THREE MILE ISLAND NUCLEAR STATION, UNIT 1 (TMI-1)  
OPERATING LICENSE NO. DPR-50  
DOCKET NO. 50-289

SUBJECT: 10 CFR 21 NOTIFICATION – IDENTIFICATION OF DEFECT  
Issue Report 741412

**Actuator in extreme full down position (-5/32 inch from installed reference position).**

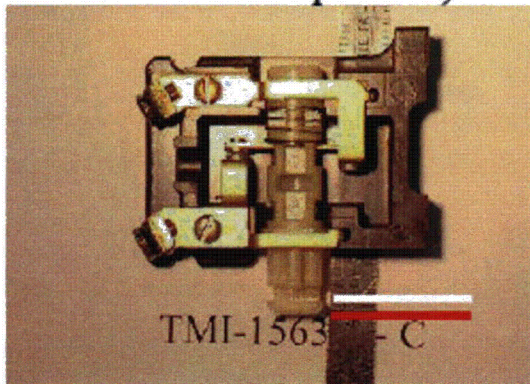
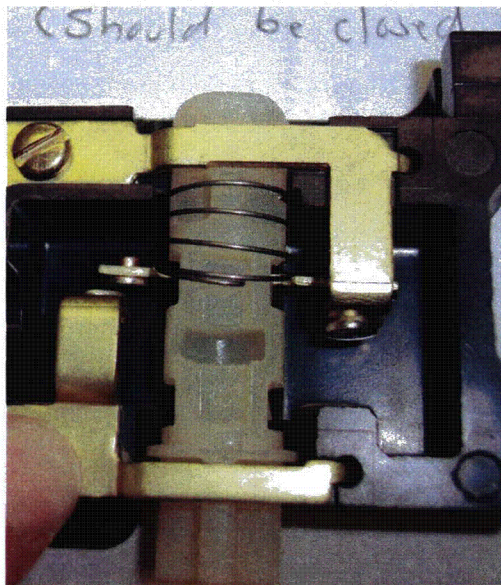
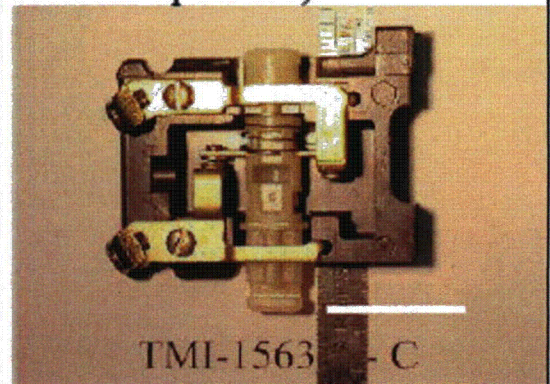
When the nylon carrier is allowed to drop to the full down position as demonstrated below in the picture on the left, the moving contactor is parallel with the lip of the slot, and there is a potential for the moving contactor to become hung-up on the lip of the slot. The nylon carrier is allowed to drop to the full down position prior to installation, and when the magnet kit and coil have been removed from the relay. Once installed in a relay, the magnet kit/coil keep the contact in the reference position as shown in the picture on the right, and the moving contactor cannot become hung-up on the lip of the slot.

**Actuator in installed down position (0.0 inches installed reference position).**

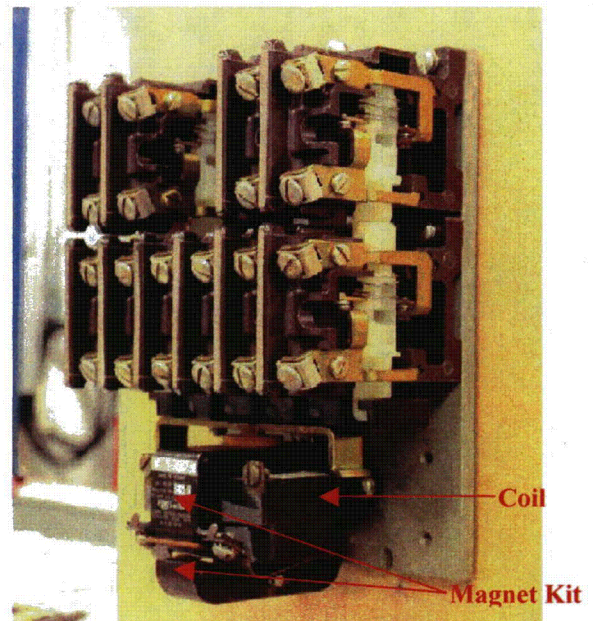
Moving contactor shown hung-up on the lip. Note the contact should be closed in this state, but is not able to fully close due to being hung-up.

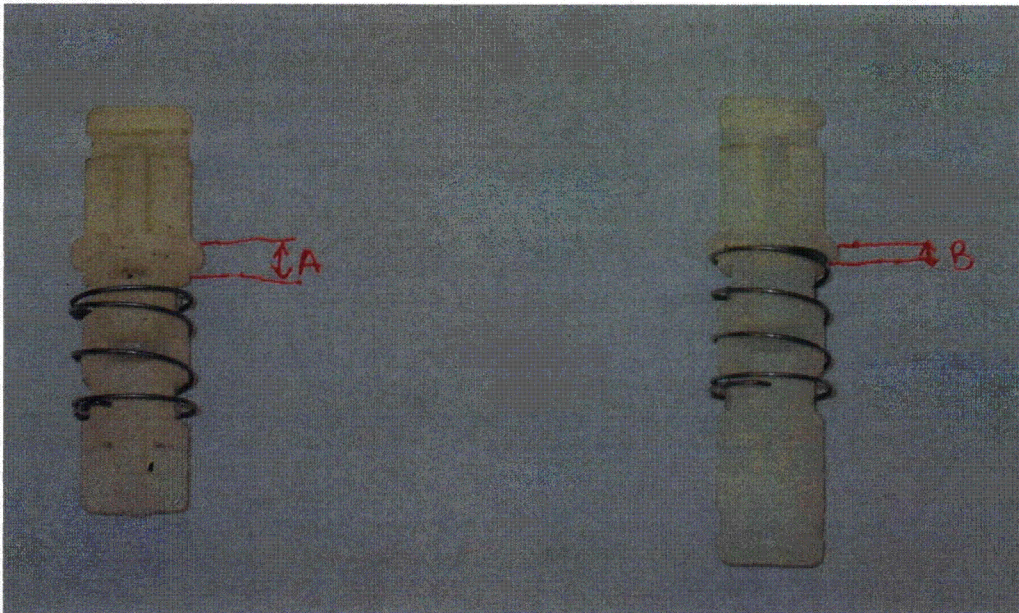
Only the open top N/C contact assemblies are subject to this vulnerability, due to the difference in the size of a retaining ring between the closed top and open top assemblies. The larger ring utilized in the closed top contact assemblies prevents the nylon arm from dropping down. (A in the picture below) The smaller ring utilized in the open-top assemblies allows the nylon arm to drop down. (B in the picture below)

1. The Commercial Grade Dedication (CGD) plans as well as the maintenance procedures have been enhanced to prevent a relay from being placed into service with an improperly configured contact. The CGD plans have been revised such that the contacts are verified to be configured correctly during receipt inspection. Maintenance procedures have also been revised to ensure the contact configuration is correct after the relay is fully assembled and following maintenance involving magnet kit/coil replacement, contact replacement, or entire relay replacement. This type of maintenance creates a scenario where the contact carrier is allowed to drop down, which creates a potential for the moving contactor to get hung-up.
